URGENT Field Safety Notice Update

Philips Allura and Azurion systems
Risk of patient fall from the table associated with the use of the mattress

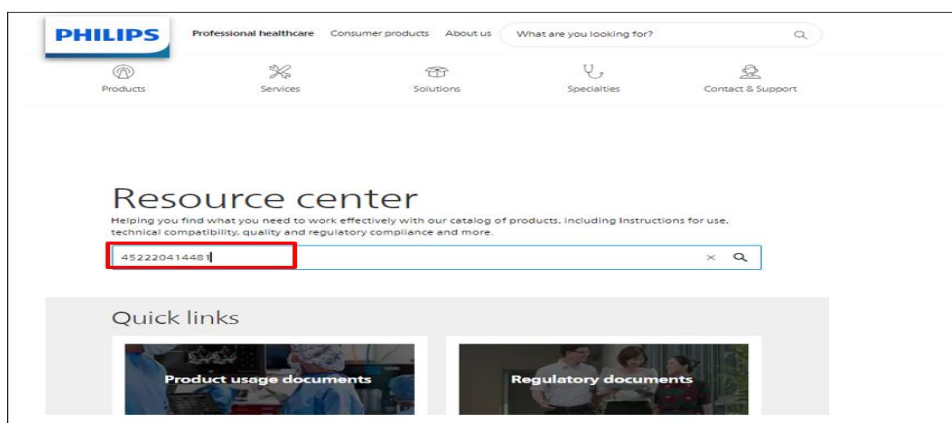
1. Use the following link below or QR Code to access the site with the IFU addendum and Quick Reference Card:

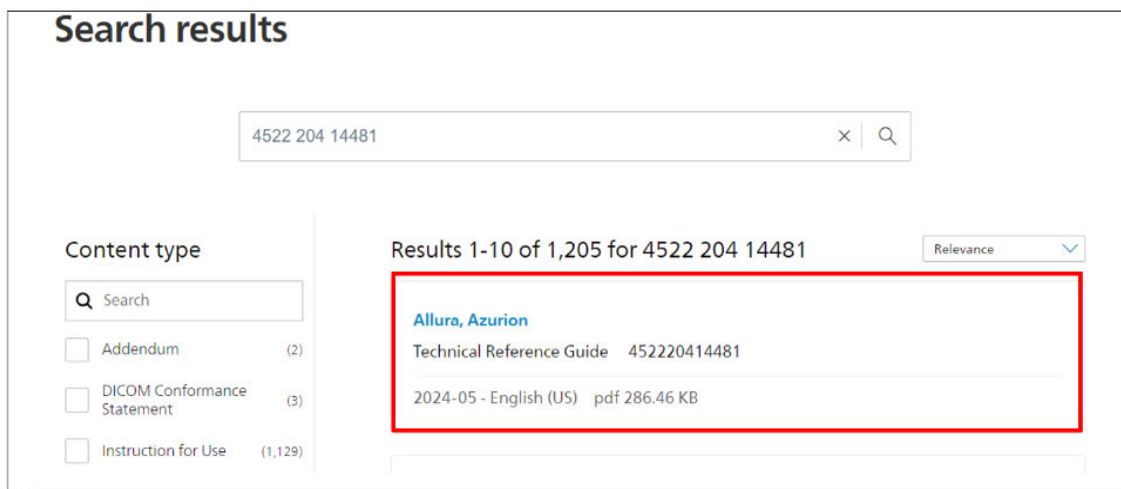
Language codes for the IFU addendum and QRC

Language	Language code for QRC	Language code for IFU addendum for CE Mark countries	Language code for IFU addendum for Non CE Mark countries	Language code for IFU addendum for systems manufactured in China
American English	4522 204 14482	4523 001 30522	4523 001 30852	-
Bahasa Indonesian	4522 204 14602	4523 001 30592	4523 001 32482	-
Brazilian Portuguese	4522 204 14712	4523 001 30702	4523 001 32592	-
Bulgarian	4522 204 14492	4523 001 30472	4523 001 32382	-
Croatian	4522 204 14582	4523 001 30572	4523 001 32462	-
Czech	4522 204 14502	4523 001 30482	4523 001 32392	-
Danish	4522 204 14512	4523 001 30492	4523 001 32402	-
Dutch	4522 204 14692	4523 001 30682	4523 001 32572	-
Estonian	4522 204 14552	4523 001 30542	4523 001 32432	-
Finnish	4522 204 14562	4523 001 30552	4523 001 32442	-
French	4522 204 14572	4523 001 30562	4523 001 32452	-
German	4522 204 14522	4523 001 30502	4523 001 32412	-
Greek	4522 204 14532	4523 001 30512	4523 001 32422	-
